SAFETY RECALL

SR17-09B

DATE:	May 2017	SECTION: 23 ACCESSORIES
SUBJECT:	LOWER WIND	SHIELD WIPER ARMS INSPECTION

REVISION B: THIS SAFETY RECALL SUPERSEDES PREVIOUS VERSION.

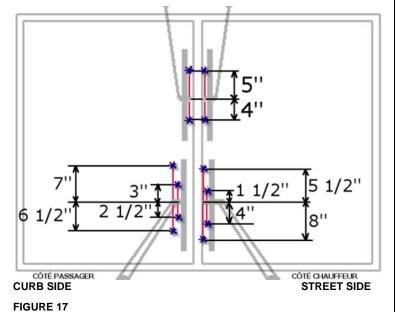
- 21. Adjust the jets position such a way that the washer jets reach the windshield at the locations indicated with a «* » symbol (FIGURE 17).
- 22. To adjust, insert a needle into the hole and rotate the ball according to the desired position of the jets.
